## *TECHNICAL NOTE 94.43*

### **Filtration Unit Optimisation: Hardware procurement and upgrading activities**

| Reference/Référence          | MELISSA Pilot Plant Frame Contract 19445/05/NL/CP |

**MELISSA Pilot Plant  
Filtration Unit Optimization  
Technical Note 94.43**

Figure 3 : Micro-Module ports

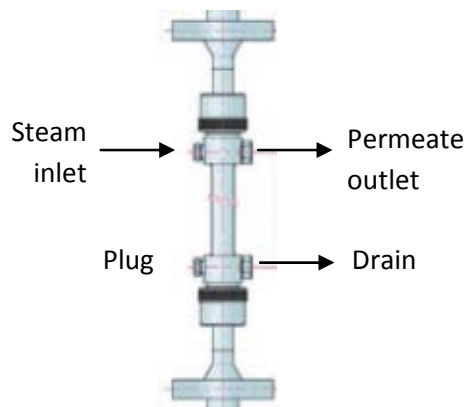
| <p>paragraph</p>                               | <p>I do not see on the new module the temperature sensors which were initially present to avoid problems during sterilisation and potentially cleaning. How do you suggest to manage?</p> <p>Do you mean on the scheme on Fig. 3? We are maintaining this sensors in the new modules (TT_1200_02 and TT_1200_03 in the PID, page 16)</p>  |

Figure 4 : Schema of filtration unit

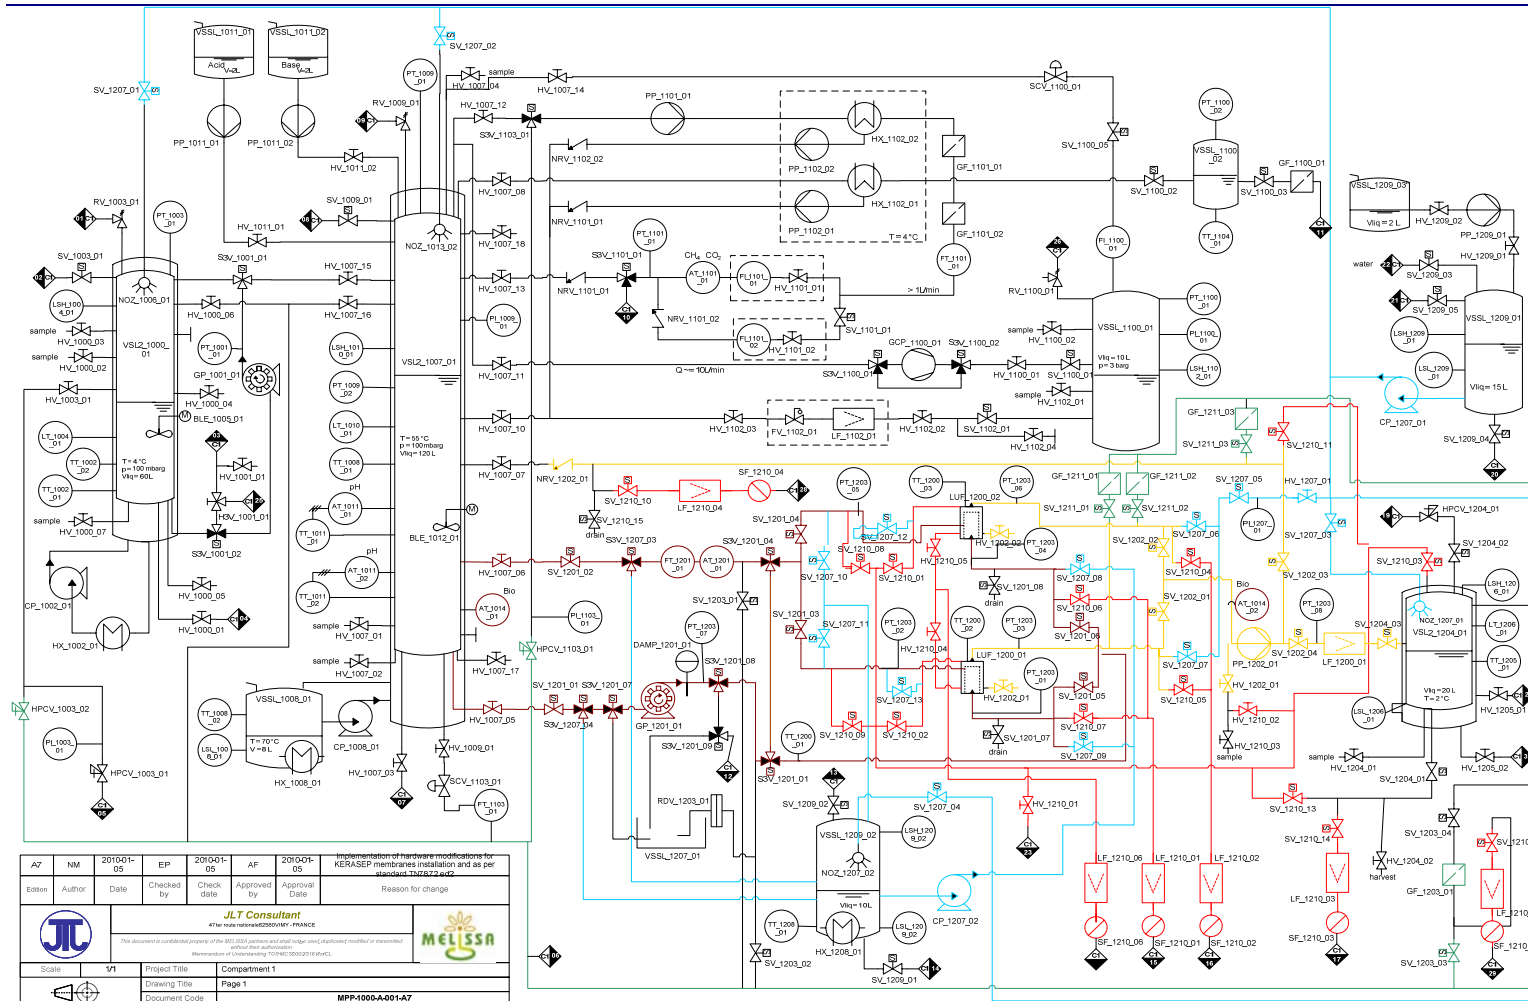
| Page/paragraph                     | Comment  |
|------------------------------------|--|
| 7/ Section III, first paragraph    | <p><i>"The simplified scheme of the filtration unit before upgrade with KERASEP membranes is provided on page 9"</i><br/>Please refer to a .figure number . I don't see any scheme on page 9; if you refer to figure 4 , then I don't know if the wording "simplified" scheme is really appropriate</p> <p>OK, amended: <i>"The scheme of the filtration unit before upgrade with KERASEP membranes is provided on Figure 4"</i></p> |
